**CITY OF DOVER**

## PLANNING TECHNICAL REVIEW COMMITTEE –AGENDA

Meeting Type: Regular Meeting  
Meeting Location: Council Conference Room, City Hall, 288 Central Ave, Dover NH 03820  
Meeting Date: **Thursday, November 6, 2025**  
Meeting Time: **10:30 AM**

SITE PLAN  
9-11 MECHANIC STREET, DOVER NH,  
ASSESSOR'S MAP 24 LOT 101  
DOVER PLANNING FILE #

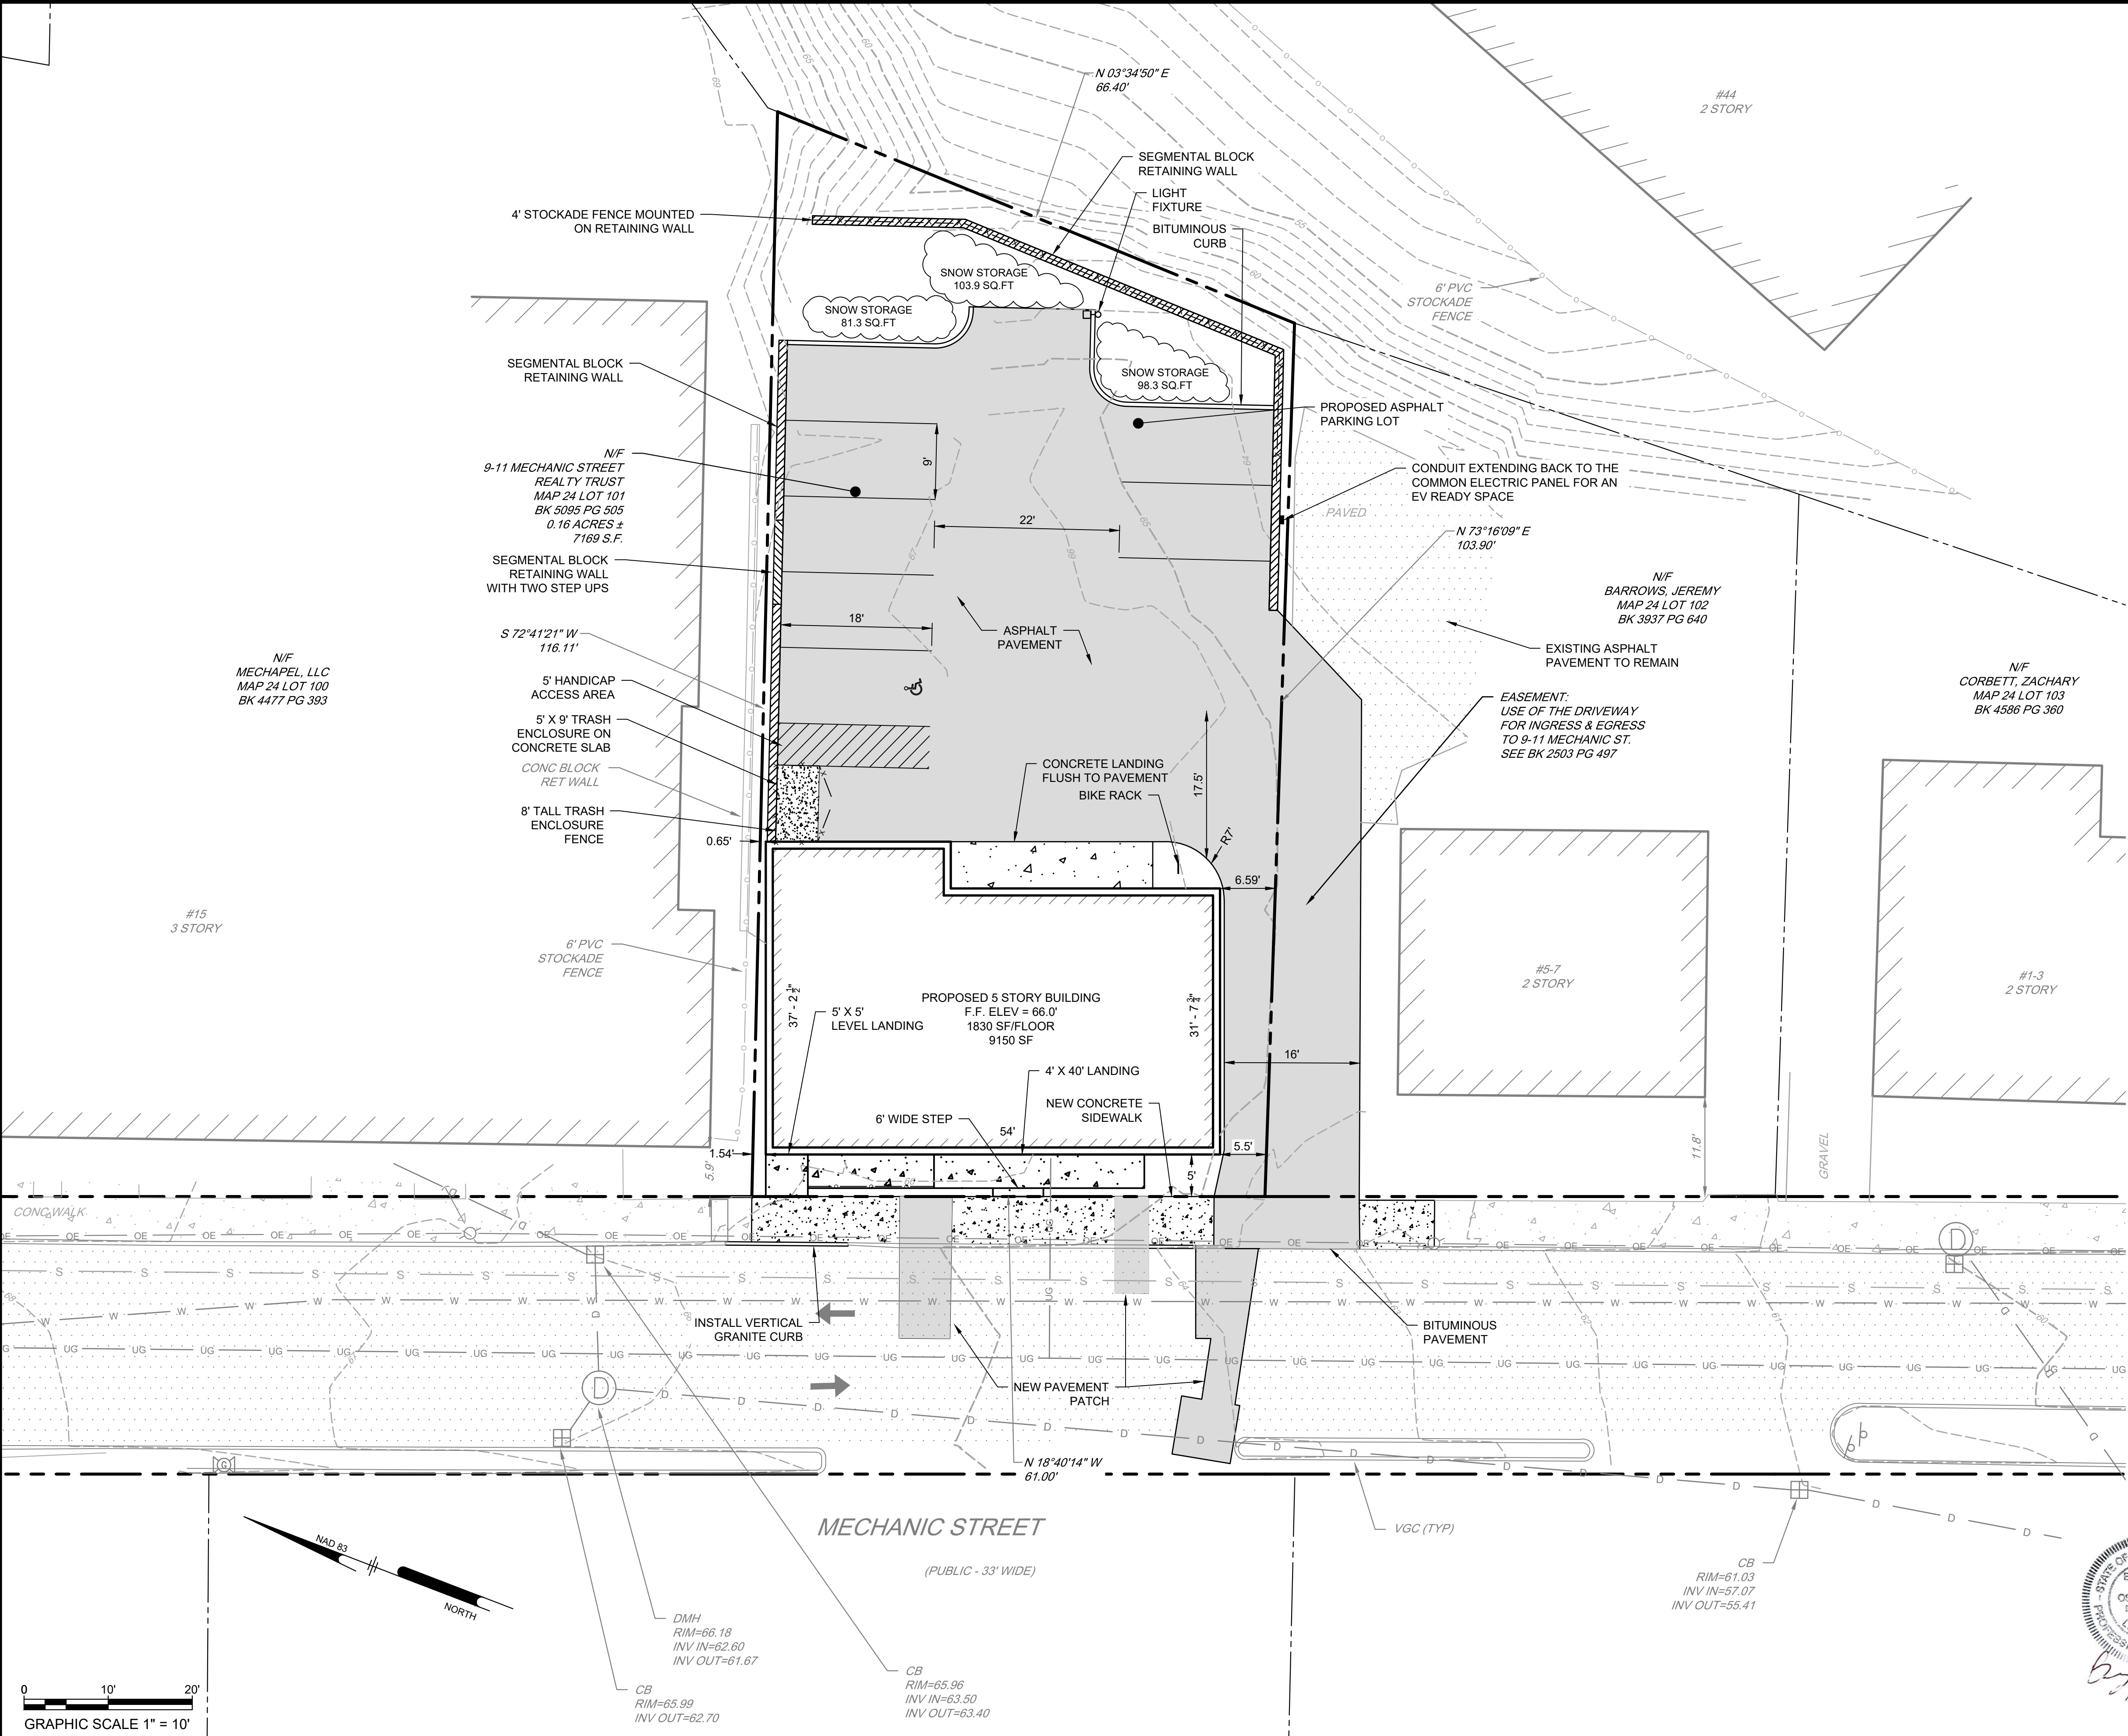
- Sheet 4 of 11 Layout & Materials CS1001
  - 22' width between parking spaces is a tight turnaround area. An additional small pavement area at the rear of the parking lot is recommended to facilitate turnarounds.

- Will driveway with easement be paved?
  - Driveway apron must be HMA.
  - Label granite curb as vertical granite curb.
- Sheet 5 of 11 Grading & Drainage Plan

- **City standard details have been added to the plans.**
- Sheet 4 of 11 Layout & Materials CS1001
  - 22' width between parking spaces is a tight turnaround area. An additional small pavement area at the rear of the parking lot is recommended to facilitate turnarounds.

- **The granite curb is labeled as vertical granite curb**
- Sheet 5 of 11 Grading & Drainage Plan
  - Clarify top elevation of rear retaining wall at changes in direction.

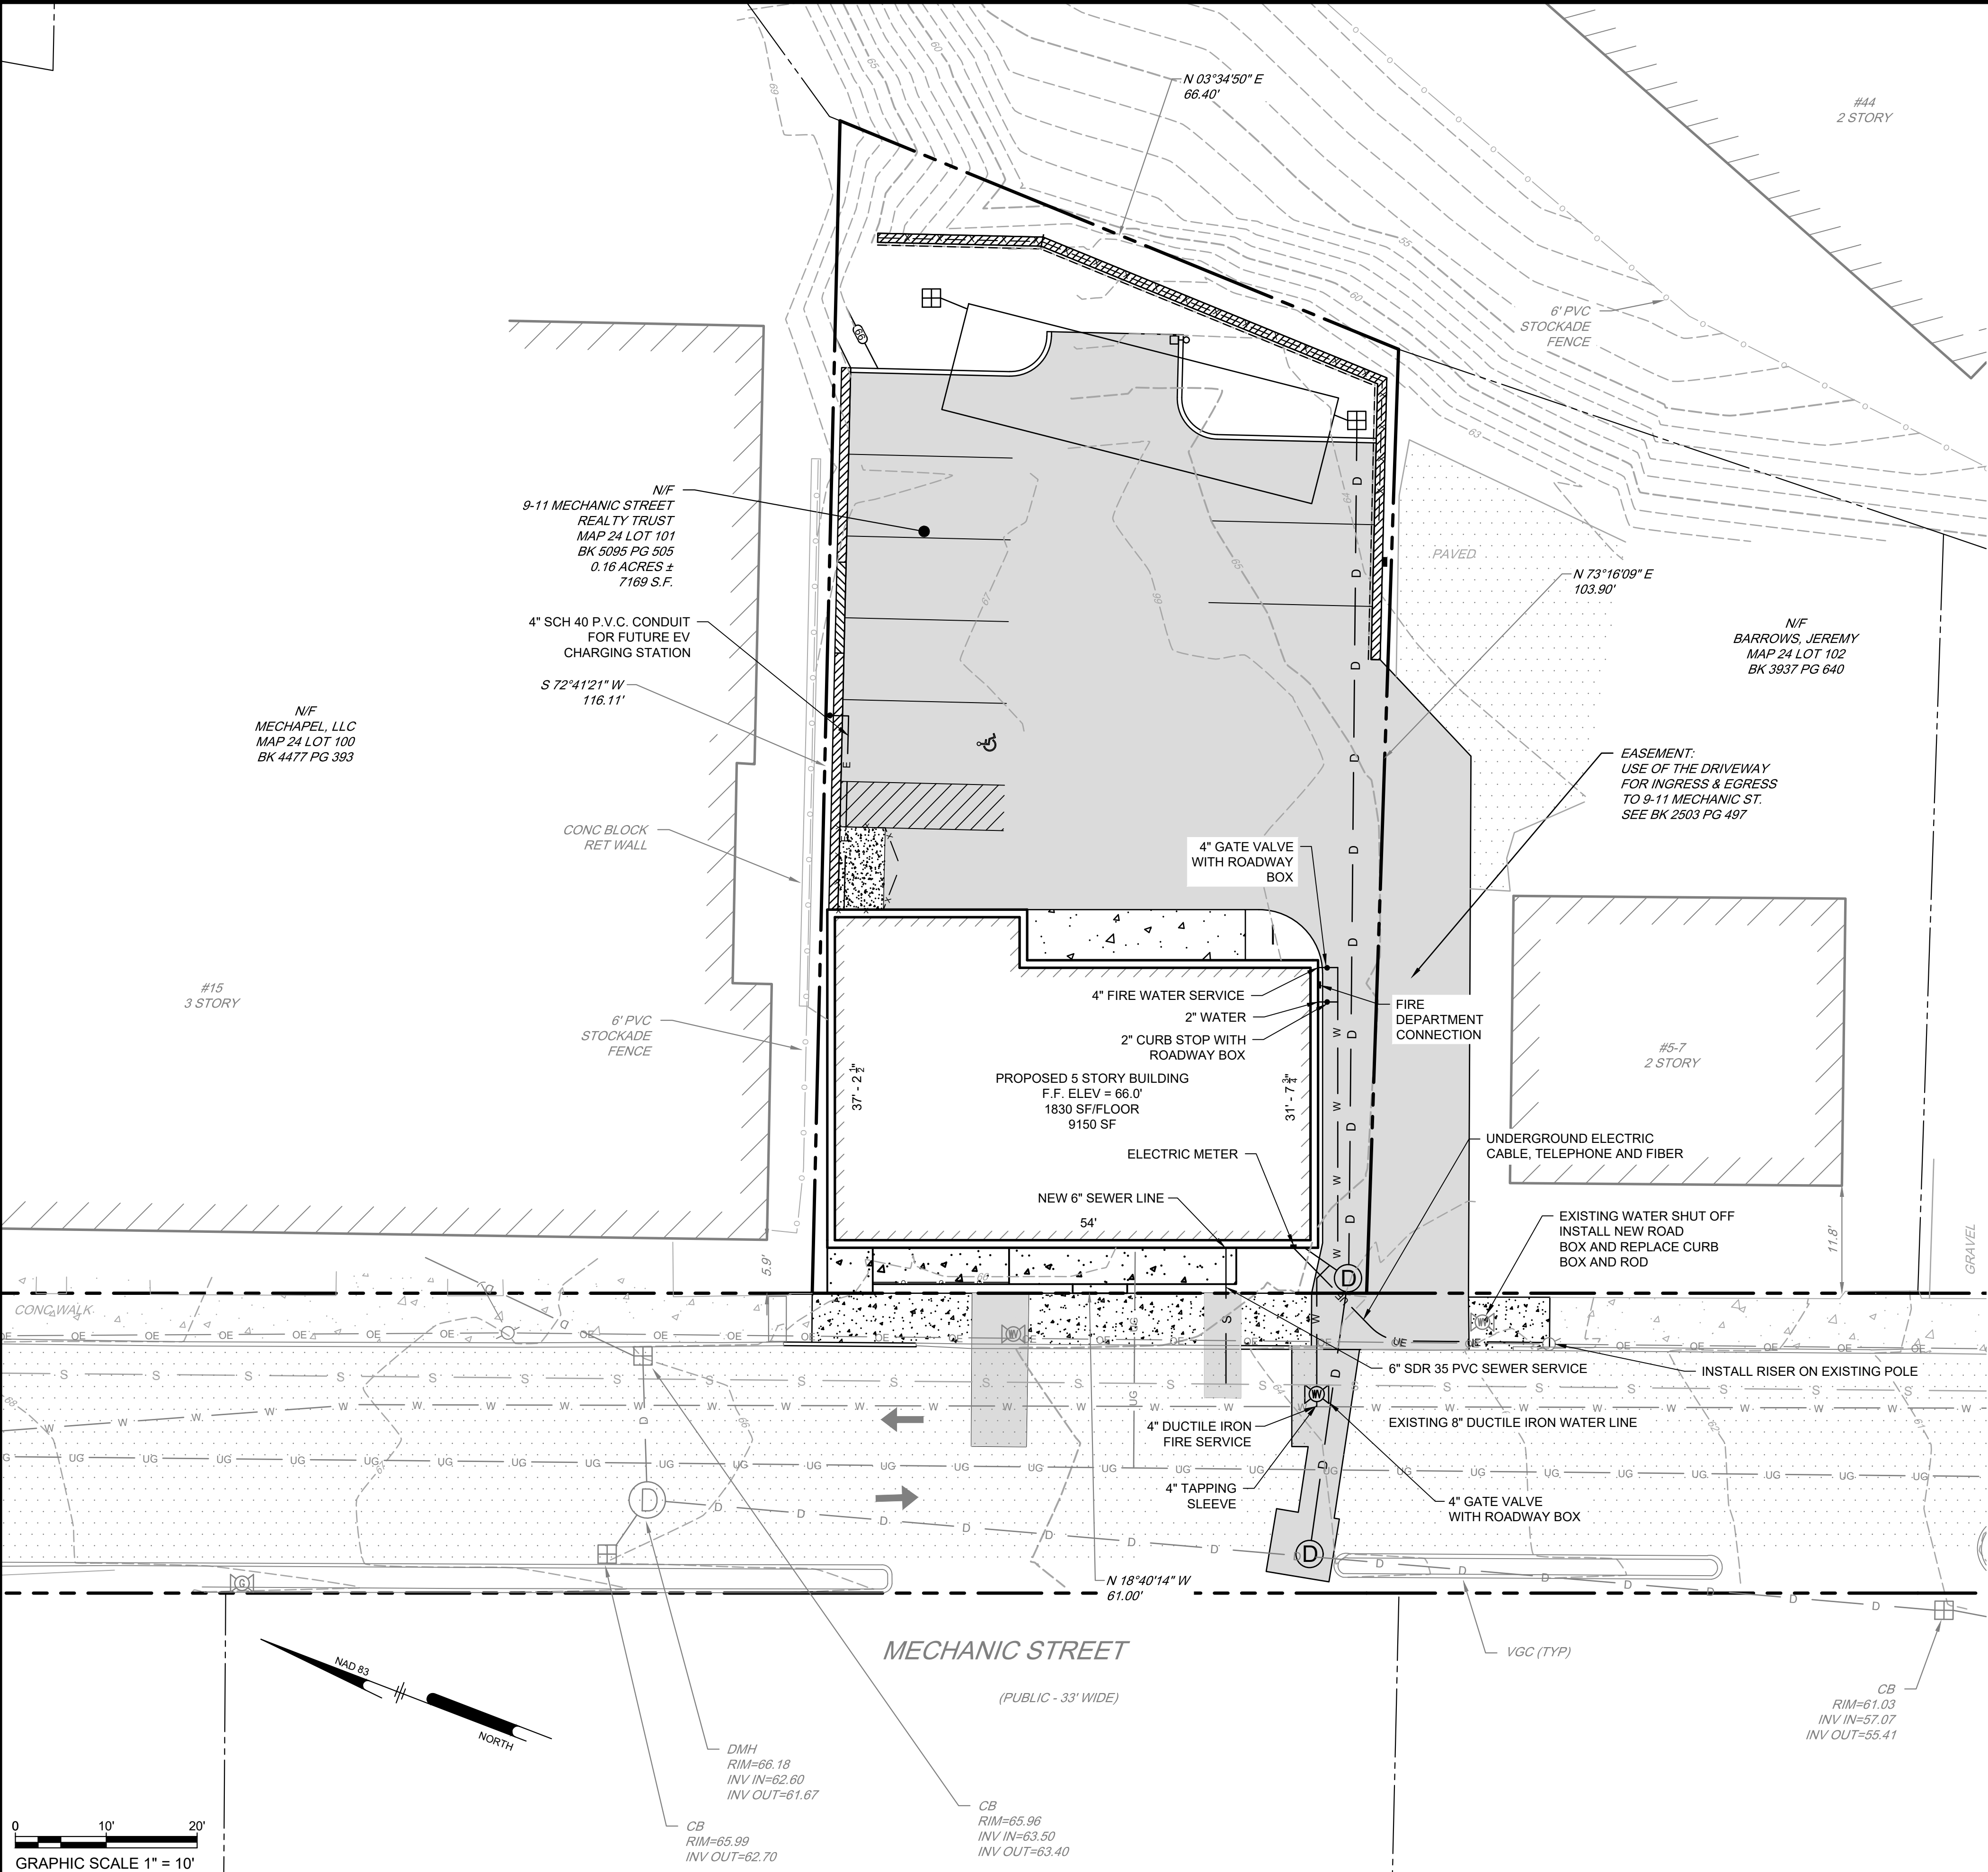
- Sheet 6 of 11 Utility Plan CS1601
  - Gate box required to cover curb box in sidewalk
  - Tapping gate to be at tapping sleeve
  - Show existing water service to be removed, if new services is to be installed.

- Sheet 6 of 11 Utility Plan CS1601
  - Gate box required to cover curb box in sidewalk
    - **A gate box has been added**
  - Tapping gate to be at tapping sleeve
